2.5 Geology, Seismology, and Geotechnical Engineering

In Section 2.5, “Geology, Seismology and Geotechnical Engineering,” of the site safety evaluation report (SSAR), the applicant, System Energy Resources, Inc. (SERI), provided a detailed description of the geological, seismological, and geotechnical engineering properties of the early site permit (ESP) site. In this safety evaluation report (SER), Section 2.5.1, “Regional Geology,” describes basic geological and seismological data, especially the data published since 1986 for the area within a 200-mile radius of the ESP site, and presents updated seismic sources. Section 2.5.2, “Vibratory Ground Motion,” evaluates the vibratory ground motion for the ESP site and analyzes the safe-shutdown earthquake (SSE) ground motion. Section 2.5.3, “Surface Faulting,” describes the potential for surface faulting at or near the surface of the ESP site. Section 2.5.4, “Stability of Subsurface Materials and Foundations,” presents the results of site geotechnical investigations and discusses the stability of subsurface materials and foundations. Section 2.5.5, “Stability of Slopes,” defers the analyses for slope stability at the site and dam perf

15224 Grand Gulf

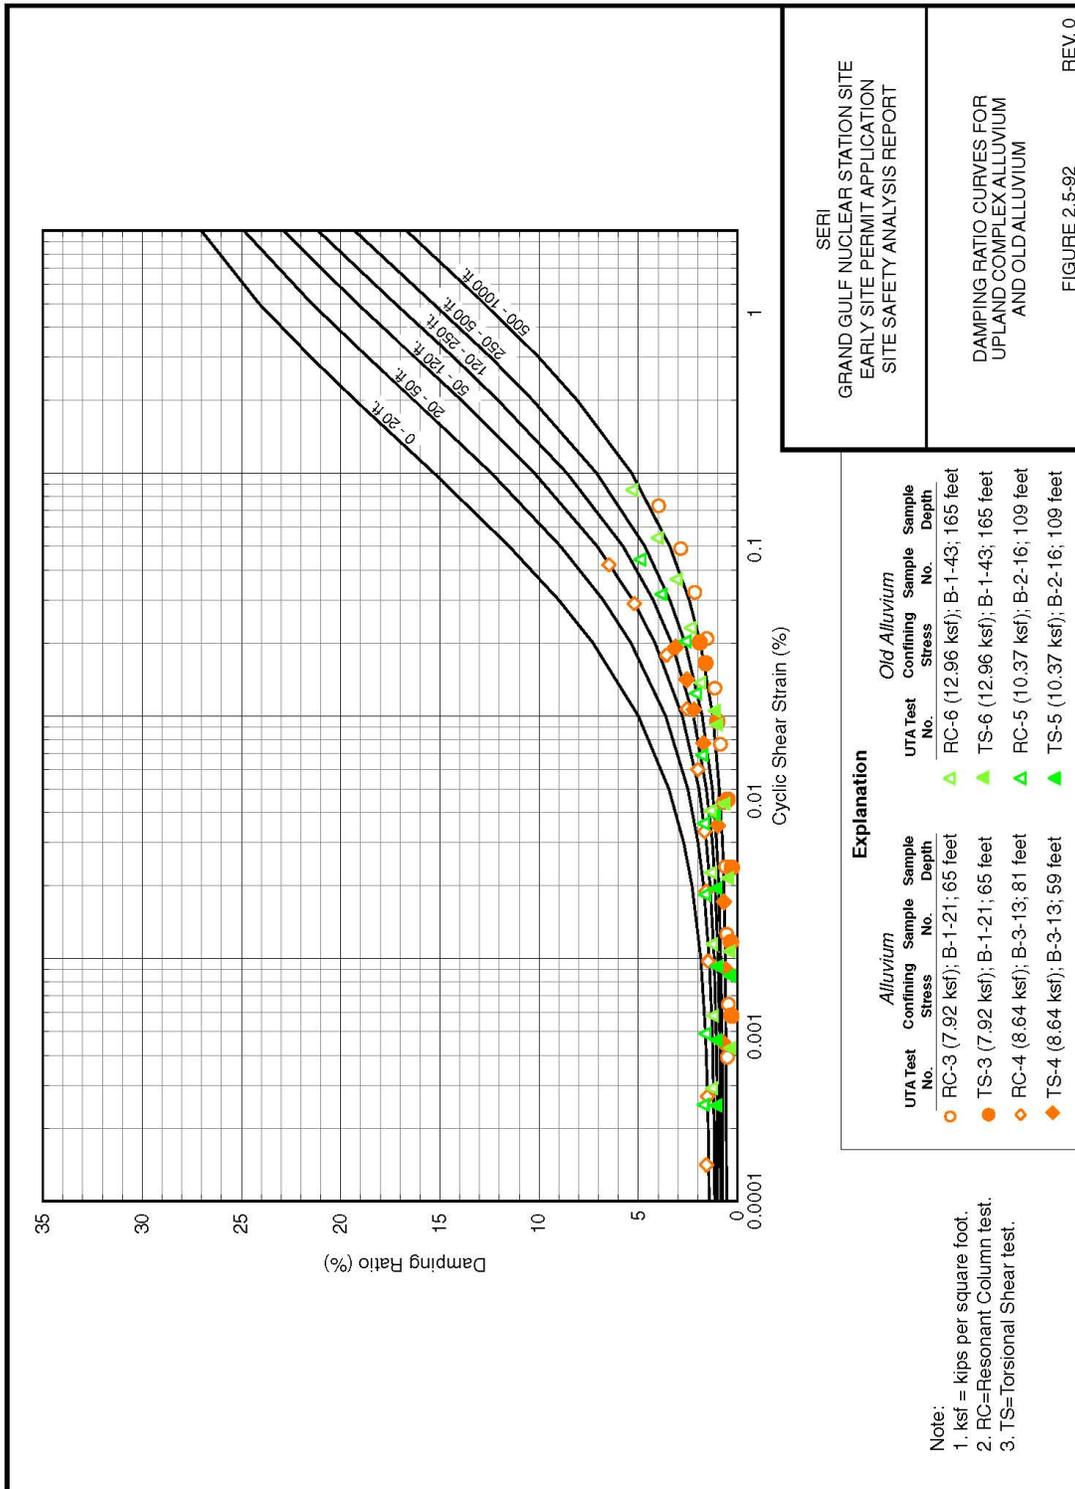
In RAI 2.5.4-7, the staff asked the applicant to provide its rationale for not incorporating these effects in the site response calculations and to evaluate the potential impact of these modifications on the computed surface UHS. In its response, the applicant referred to its response to RAI 2.5.4-6 and stated that the analysis and selection of the appropriate EPRI-TR curves for shear modulus reduction and hysteretic damping fully account for the effects of possible disturbance to the test specimens resulting from stress release during sampling, as well as possible movements during testing. The applicant considered the effects of sample relaxation by examining the results from testing soils at both the estimated in situ confining stress and 4 times the estimated in situ confining stress. The applicant plotted these two data sets together on the EPRI-TR base curves as shown in Figures 2.5.4-5 through 2.5.4-12, which replicate SSAR Figures 2.5.4-87 to 2.5-94 and Figures 2.5.4-13 and 2.5.4-14. The two data sets were weighted to select the most representative EPRI-TR curve.

In its response, the applicant further stated that the shear modulus reduction and damping curves adopted for use in the site response analysis represent the best fit to the dynamic soil test results that account for the effects of soil disturbance and overconsolidation. The applicant also considered the uncertainty and variability in these values in the site response modeling by developing randomizing curves about the selected base case EPRI-TR curves using an assumed lognormal distribution. The applicant further discussed the randomization process in its response to RAI 2.5.4-8 (for shear wave velocity input). The applicant considered that the EPR-TR curves selected for the base case for site response analysis are appropriate for the site soil conditions and account for both sample disturbance and overconsolidation. Therefore, incorporation of these issues would not impact the computed surface UHS.

(Figure 2.5.4-16) (Figure 2.5.4-4-1 of the RAI response)

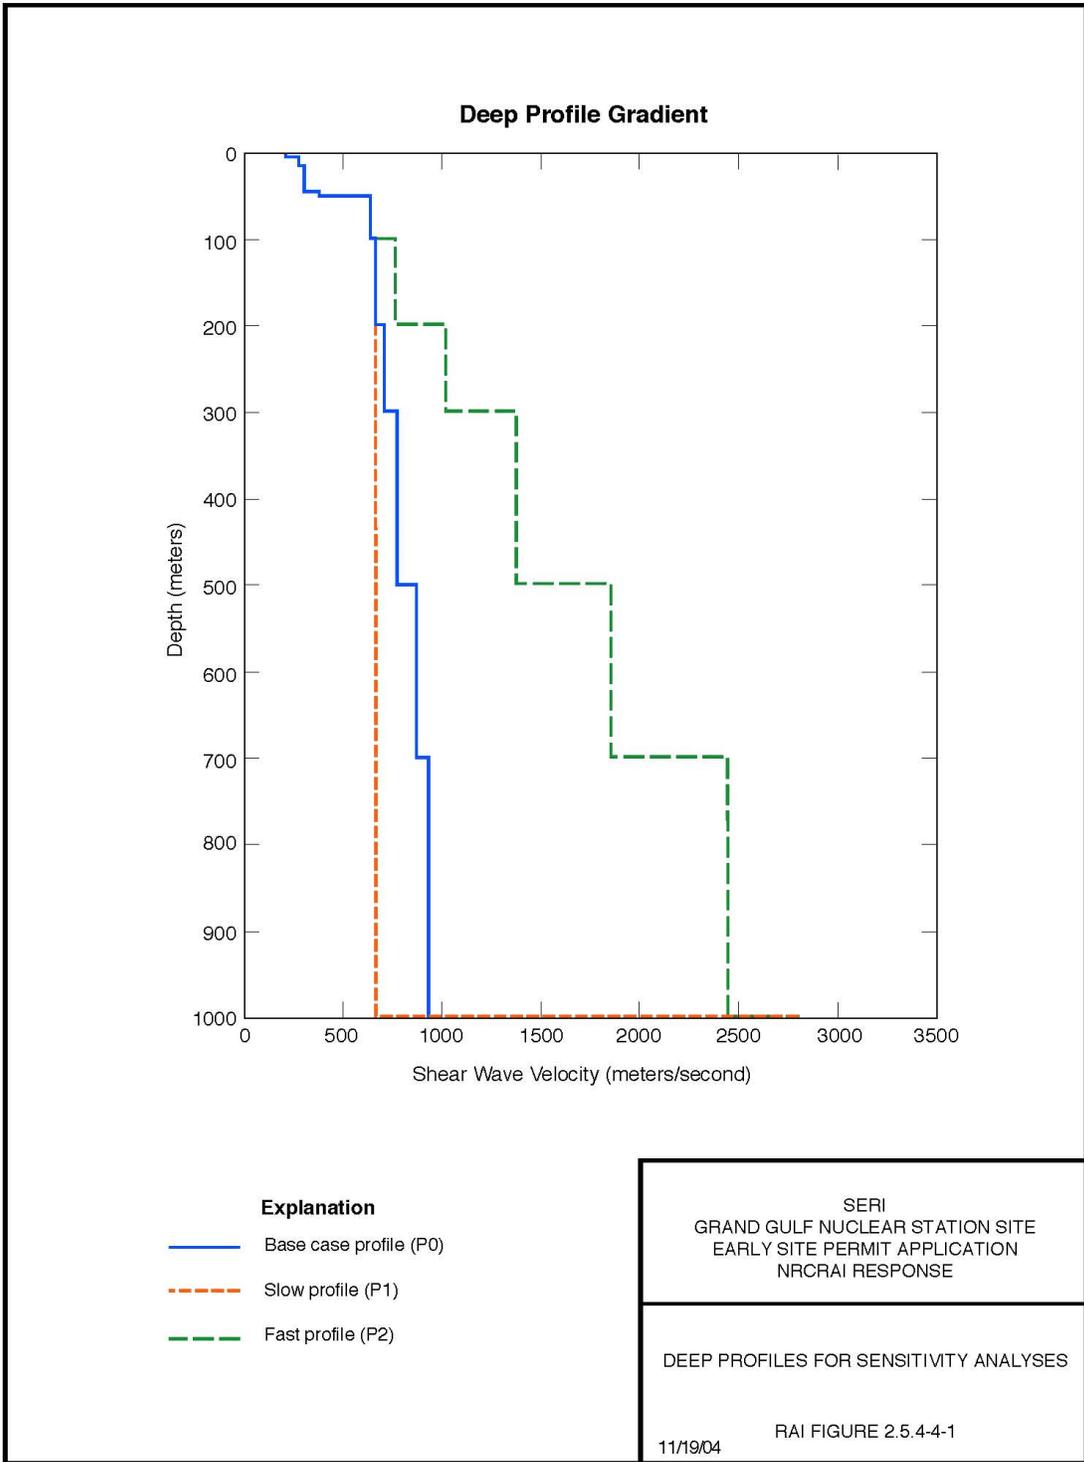
In seismic response analyses, shear and compression wave velocities, material densities, and strain-dependent modulus reduction and hysteretic damping data are necessary for the entire soil column extending to the depth considered in the site response evaluation. As indicated in Figure 2.5.2-4, the applicant assumed that the hard rock, with a shear wave velocity of 9186 fps, is located at a depth of 3281 feet and adopted a generic profile proposed for the Mississippi embayment region. This shear wave profile is relatively smooth, with a shear wave velocity varying from approximately 820 fps at the ground surface to a value of 9186 fps at depth of 3281 feet. The applicant also replaced the upper 197 feet of the profile with a site-specific velocity profile generated by the geophysical program described previously. Therefore, of the entire 3281 feet of the profile, only the upper 197 feet are reasonably constrained. No site-specific information is available below this depth. However, it is a common practice for the sites where critical facilities are located to have one or more base case shear wave velocity models from site-specific data (e.g., well logs and deep borings) and then to generate soil UHS using the probabilistic method of NUREG/CR-6728. In RAI 2.5.4-4, the staff asked the applicant to provide the basis for selecting the generic base case velocity model as opposed to any other model that might be generated from available information for the site and its environs. In its

Figure 2.5.4-16 shows the base case shear wave velocity profile to the analysis depth of 1 kilometer along with two extreme cases for extrapolation to the hard rock shear wave velocity of 2.8 km/s. The slow profile assumes a uniform extension of the velocity just beneath the site to 1 kilometer, with a jump to the hard rock value of 2.8 km/s. As another extreme alternative, the fast profile assumes a linear (modeled as a stair step) gradient with depth, reaching 2.8 km/s at a depth of 1 kilometer. Based on general experience with measured shear wave velocity profiles in large sedimentary basins, the applicant expected the slow and fast profiles to reflect extreme (i.e., low likelihood) conditions, particularly with regard to the local and regional overall geology.

(Figures 2.5.4-17 and 2.5.4-18) (Figures 2.5.4-4-2 and 2.5.4-4-3 of the RAI response)

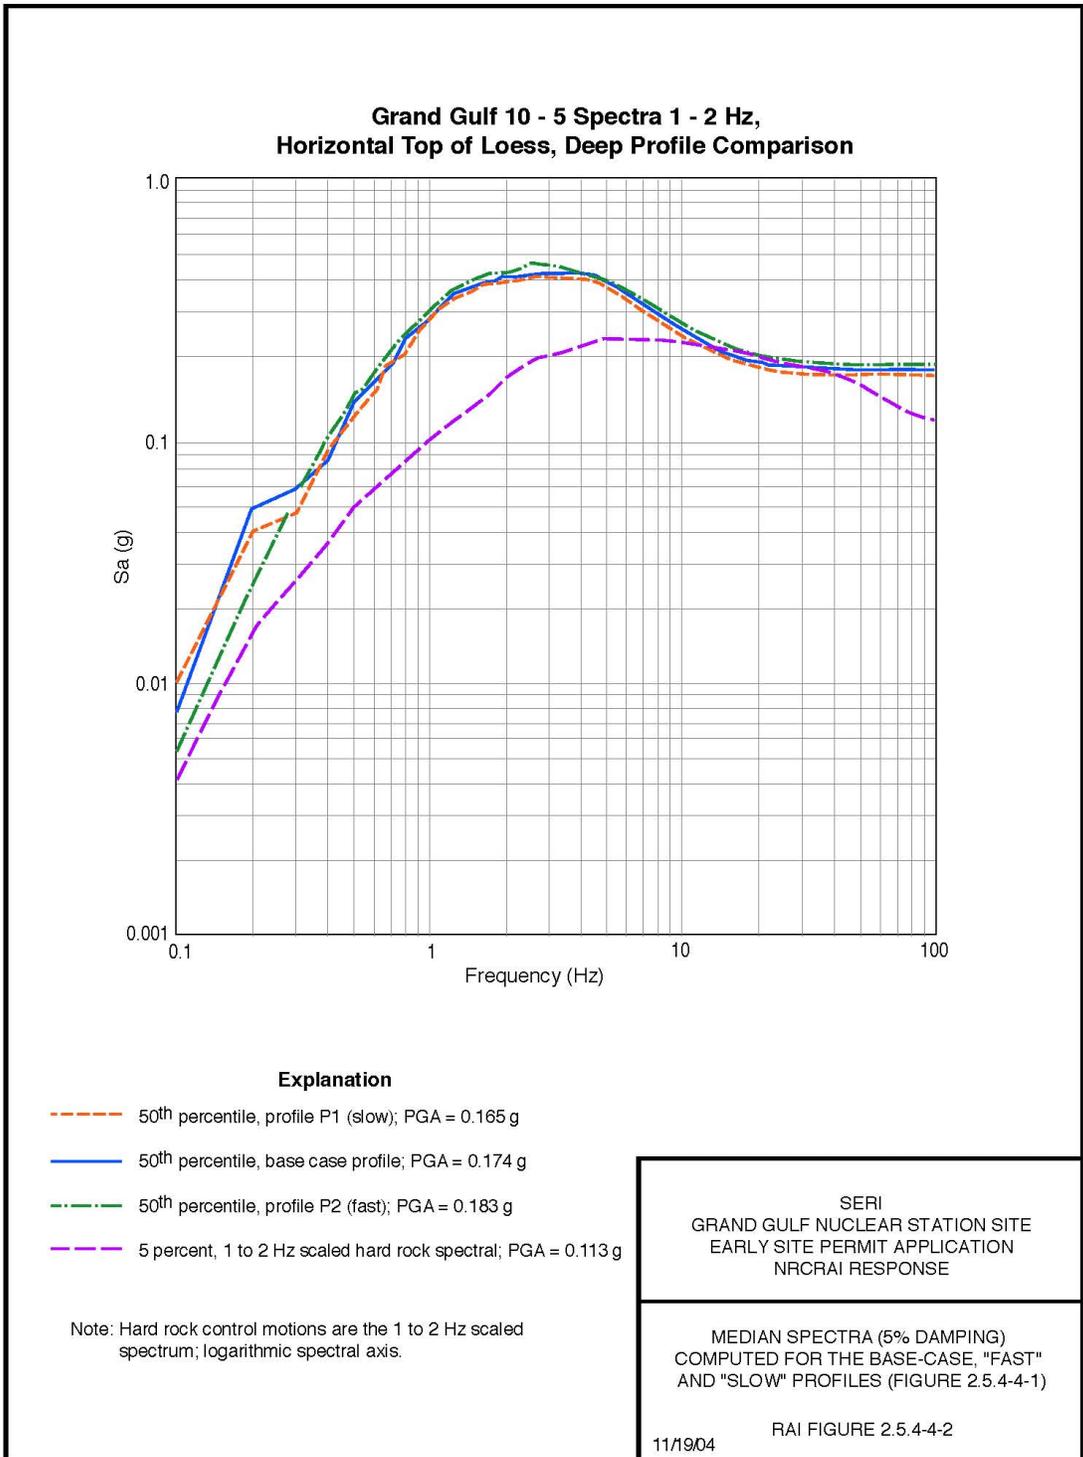
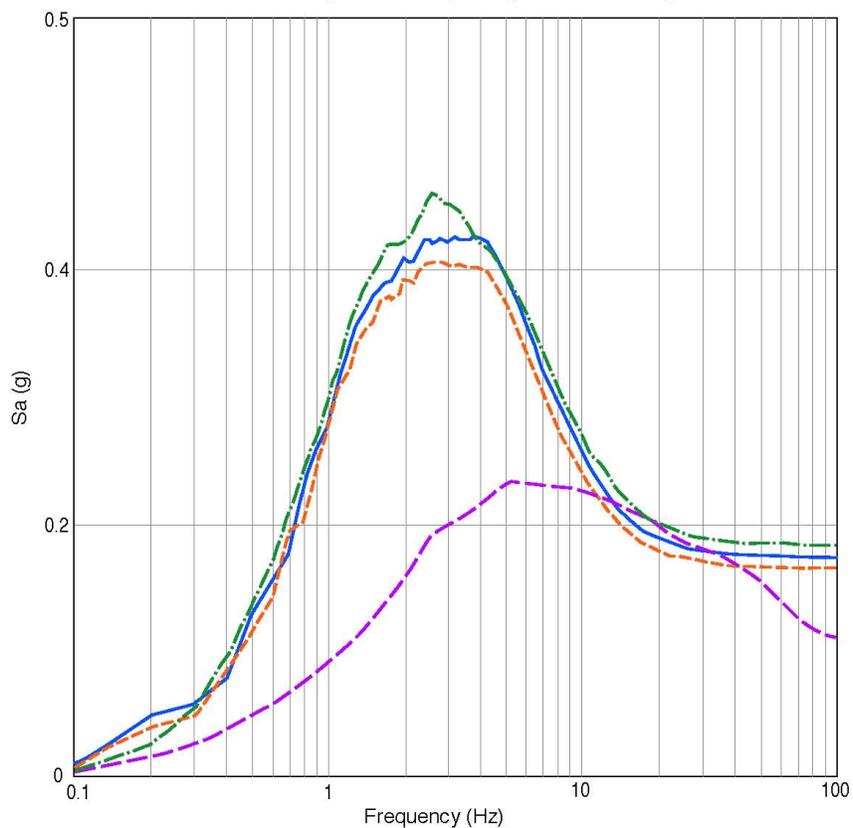
To compare the median motions computed for the three profiles, the applicant stated that it used the 1- to 2-Hz-scaled 10^{-5} APE spectrum as control motions to excite the column at low as well as high frequency since it is quite similar to the UHS and sufficiently broad band (i.e., large magnitude) compared to the UHS. Figures 2.5.4-17 and 2.5.4-18 show the resulting soil median motions in both the logarithmic and linear spectral axes, respectively. As expected, little difference exists between the motions computed for the three profiles from 0.3 to 100 Hz. At peak acceleration, the fast and slow profiles show about a 5-percent increase and decrease, respectively, in motions, as compared to the base case profile. The motions reflecting the fast profile generally exceed those of the base case by about 5 percent. The largest exceedance is near a resonance at about 3 Hz, at which the fast profile motions exceed the base case motions by about 10 percent. Based on regional geology as well as experience with similar geology in deep basins, this fast profile is extremely unlikely and would receive very low weight in a hazard analysis. The applicant stated that these site response analyses illustrate the general insensitivity of the motions to the nature of velocity gradients likely to exist in the deep materials beneath the site.
